BOARD OF COMMISSIONERS
AGENDA
Monday, July 13, 2015 - 6:30 PM

**A RESOLUTION OF RADNOR TOWNSHIP, DELAWARE COUNTY,
PENNSYLVANIA, APPROVING THE PRELIMINARY/FINAL PLANS
OF VILLANOVA UNIVERSITY FOR LOT CONSOLIDATION OF
PROPERTIES LOCATED ALONG LANCASTER AVENUE**

RE: Villanova Lot Line Consolidation – Preliminary/Final Plan
Steven Hildebrand Villanova – Applicant

BOUNDARY CONSOLIDATION PLAN
LANDS/VILLANOVA UNIVERSITY
SOUTH CAMPUS, ALDWIN TRIANGLE, MAIN LOT & PINE LOT
LANCASTER AVENUE & LITIAN AVENUE
RADNOR TOWNSHIP, COUNTY OF DELAWARE, PA.

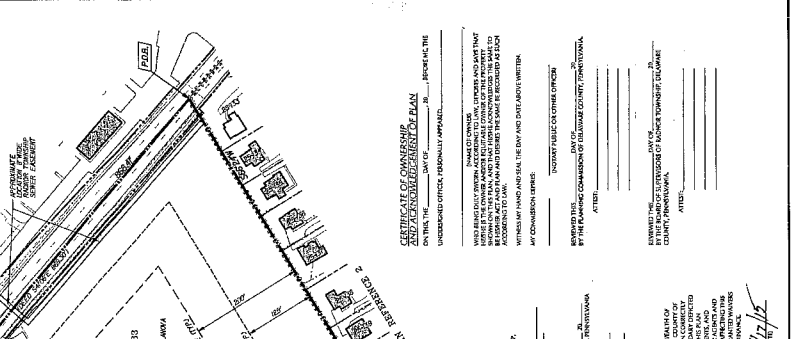
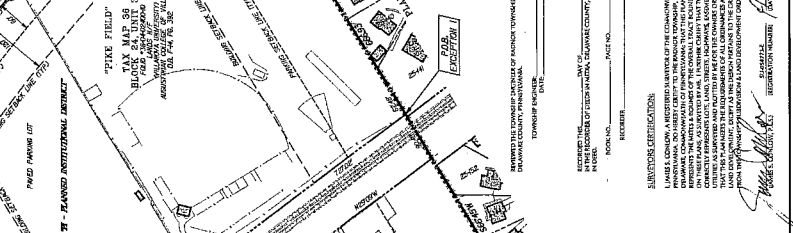
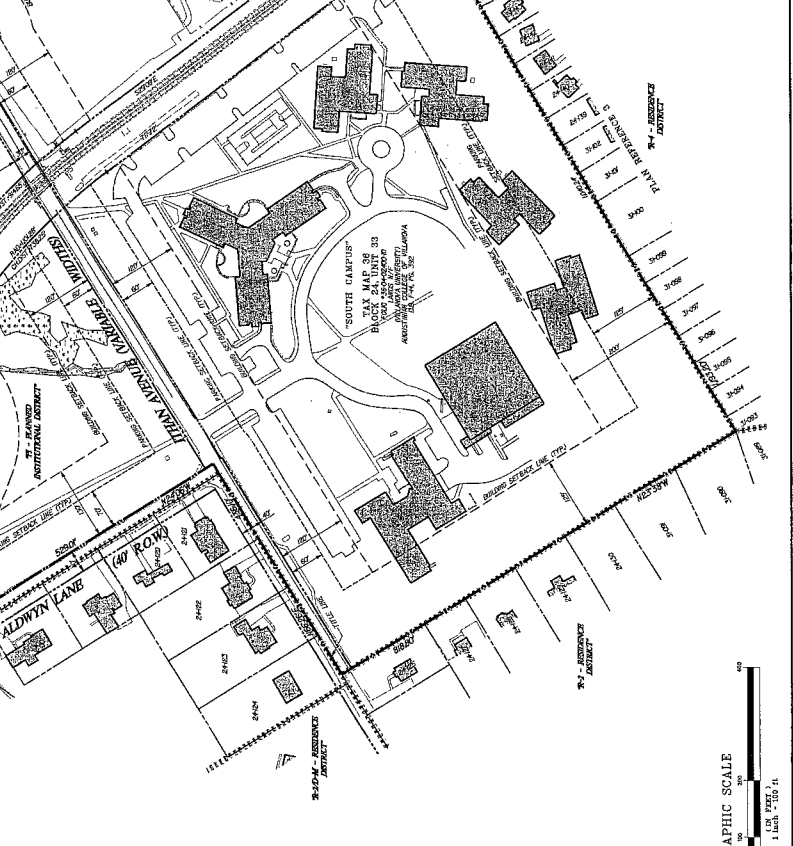
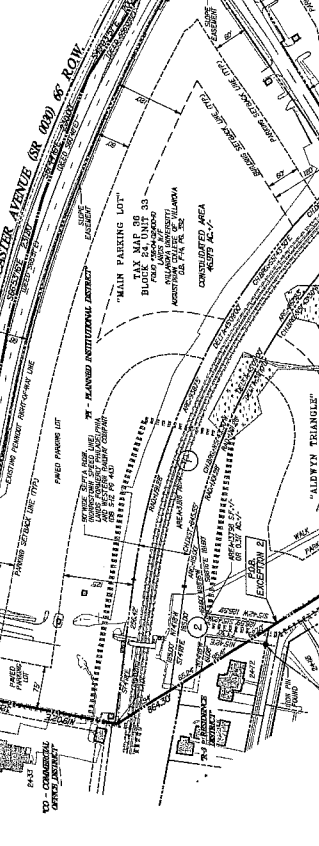
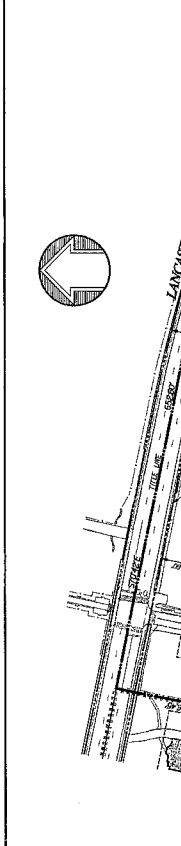
1. The description of property prepared by Nave Newell refers to a plan titled "Plan Showing Property To Be Developed By The Townsend B. Young, Co. dated March 17, 1939 and last revised October 9, 1941. A copy of this plan must be provided.

2. On Page 7 of the proposed description, the course and distance labeled "2)" appears to differ from the plan. The distance shown on the plan is 73.30 feet, but is described as 73.31. This must be revised to be consistent.
3. The consolidation plan must be signed by the Professional Land Surveyor that prepared it.

CONSOLIDATION PLAN

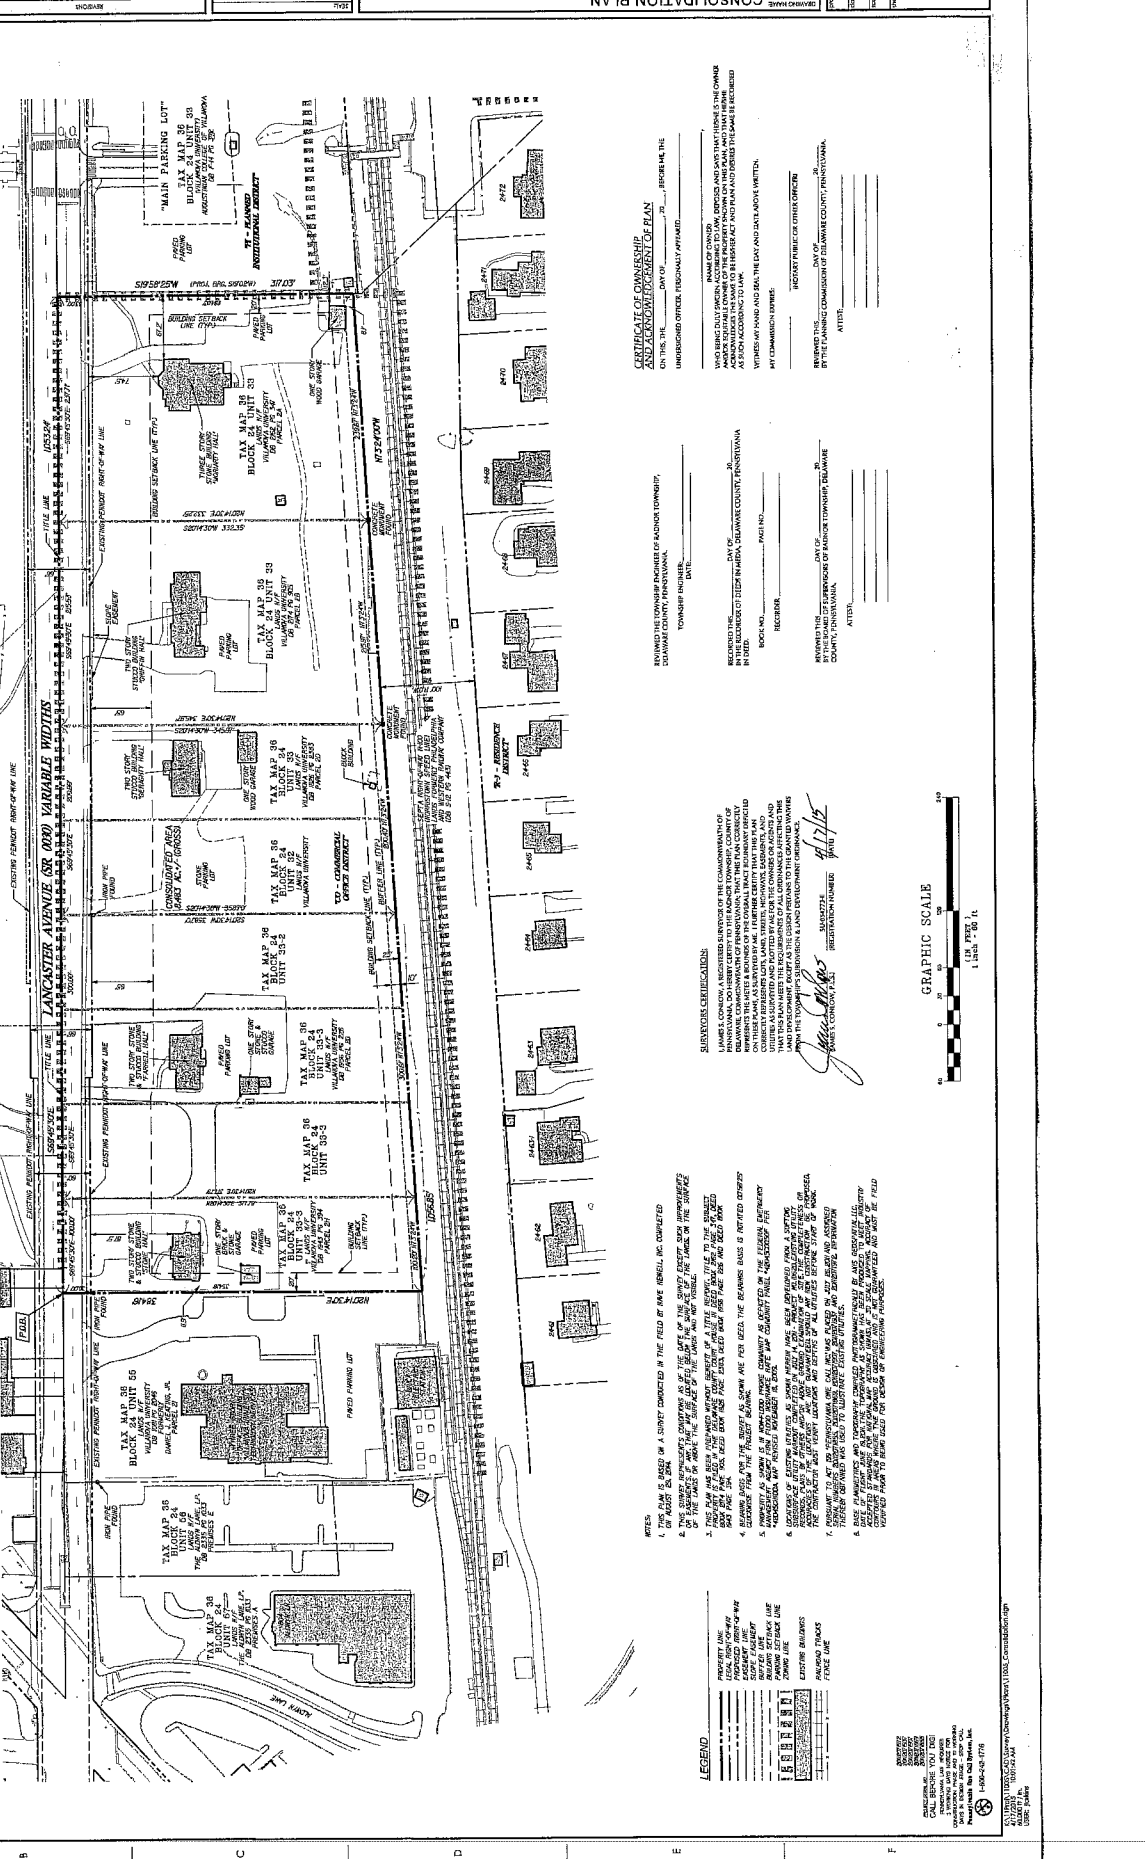
1. It appears that there is a deed missing for the lot containing Geraghty Hall. The plan indicates that this parcel is included as parcel 2D Deed Book 1826 page 2383. The referenced deed book and page number describes the lot labeled Tax Map 36 Block 24 Unit 32 on the plan. The deed must be provided.
2. The consolidation plan must be signed by the Professional Land Surveyor that prepared it.

1. The applicant has provided the deed for the lot containing Geraghty Hall that was missing from the original submission. The plan must be revised to indicate the deed book and page number of the correct deed.
2. The consolidation plan must be signed by the Professional Land Surveyor that prepared it.
